# SERVICE INFORMATION

## NO. SI 42-226

FAA Airworthiness Directive No. 2018-10-10

**2018-10-10 Diamond Aircraft Industries GmbH:** Amendment 39-19285; Docket No. FAA-2018-0188; Directorate Identifier 2018-CE-002-AD.

Figure 1 to paragraph (g)(3) of this AD:  
 Sequence of Actions for Exhaust Clamp Installation Identified in  
 DAI Work Instruction WI-MSB 42-120, Revision 3, dated July 6, 2017, and  
 Revision 4, dated December 20, 2017

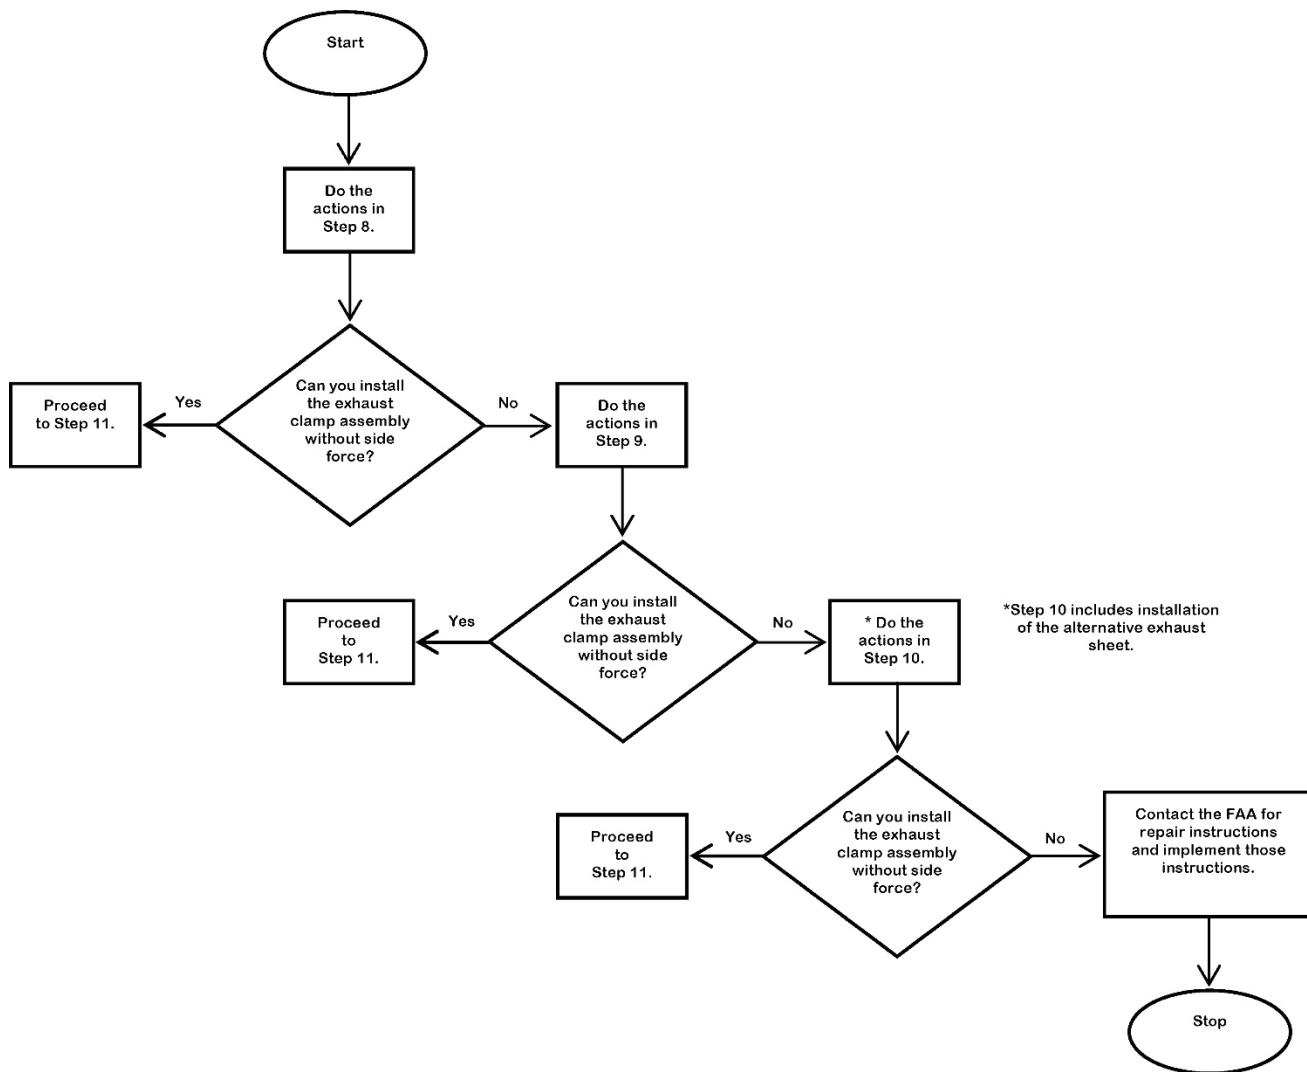
(3) Before further flight after the initial inspection required in paragraph (g)(1) of this AD and if no cracks were found or a repair to the exhaust pipe heat shield was done as required in paragraph (g)(2)(i) of this AD, then install additional engine exhaust pipe clamps, DAI P/Ns D60-7806-00-01 and D60-7806-00-02, and exhaust sheet, P/N D60-7806-00-03, and incorporate spring washers. Do the installations following III.2 Action 2–installation of additional exhaust clamp in the

INSTRUCTIONS section of DAI Work Instruction WI-MSB 42-120, Revision 3, dated July 6, 2017, or Revision 4, dated December 20, 2017. See figure 1 to paragraph (g)(3) of this AD for additional information on the sequence of installation actions as identified in DAI Work Instruction WI-MSB 42-120, Revision 3, dated July 6, 2017 and Revision 4, dated December 20, 2017.

Figure 2 to paragraph (h)(7) of this AD:  
 Sequence of Actions for Exhaust Clamp Installation Identified in  
 DAI Work Instruction WI-MSB 42-120, Revision 3, dated July 6, 2017, and  
 Revision 4, dated December 20, 2017

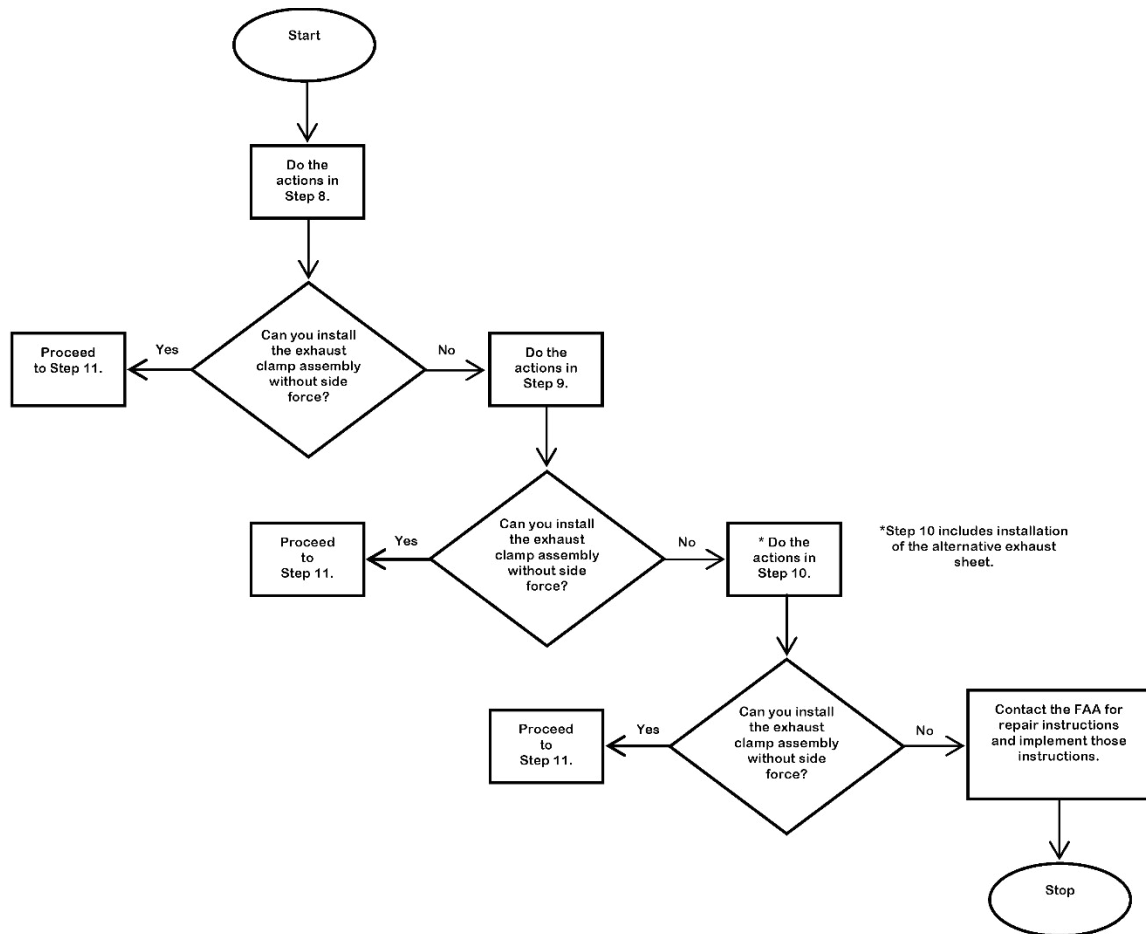
(7) Before further flight after any inspection required in paragraph (h)(6) of this AD and no crack is found, reinstall the engine exhaust pipe clamp and incorporate spring washers following III.2 Action 2–installation of additional exhaust clamp in the INSTRUCTIONS section of DAI Work Instruction WI-MSB 42-120, Revision 3, dated July 6, 2017, or Revision 4, dated December 20, 2017. See figure 2 to paragraph (g)(7) of this AD for additional information on the sequence of installation actions as identified in DAI Work Instruction WI-MSB 42-120, Revision 3, dated July 6, 2017, and or Revision 4, dated December 20, 2017. Continue with the 25-hour TIS repetitive inspection as long as no cracks are found.
